Subject: Resolution Conditions Review
1 Godwin Ave., LLC
Sola Salon
1 Godwin Ave.
Block 3, Lot 24.01
LAN Ref. #2.2428.257

Resolution Conditions of Approval

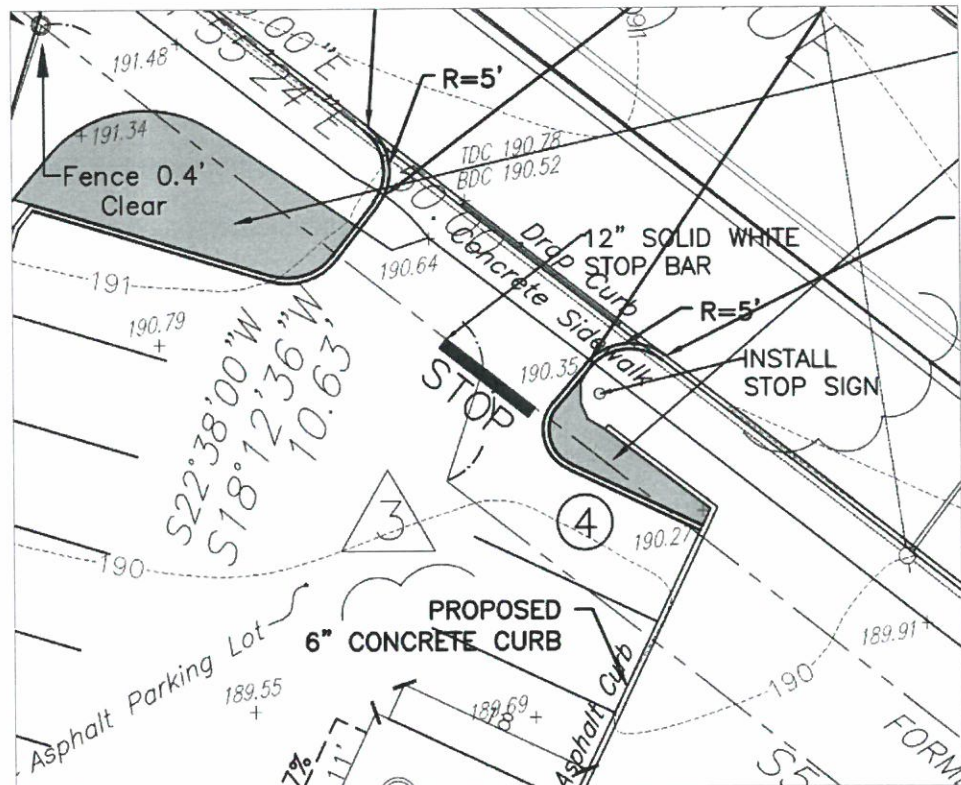
Many of the sidewalks, curbs, and driveway aprons around the property are in poor condition. Consideration should be given to replacement of these items as part of this project.

- The Godwin Ave. driveway has been reconfigured with new curbing. The old, (highlighted) curb section should be removed as part of this reconfiguration. Furthermore, the existing drop curb as shown does not align with the new curbing. This should be rectified.

- New on-site curbing is proposed along the north-west property line. The applicant proposes to locate this curbing 2' off the property line to protect the fence from vehicles parked in front of the fence. This, however, means that the actual space between the curb and the end of the parking space will only be 16', and it would be assumed that the vehicles would overhang the curb. While the intent is understandable, this is not permissible without a design waiver for the depth of the parking space, as the overhang cannot be considered part of the parking space depth. As such, the proposed curbing should be relocated to allow for full-depth parking spaces.

The revised plans indicate several sections of curbing & sidewalks to be removed and replaced.

The plans should be revised to address the highlighted curb to be removed. The previously mentioned depressed curb has been revised as suggested. This comment has been addressed.

The previously proposed curbing has been removed. Curb stops are proposed at the end of the parking spaces to protect the adjoining fence. This comment has been addressed.
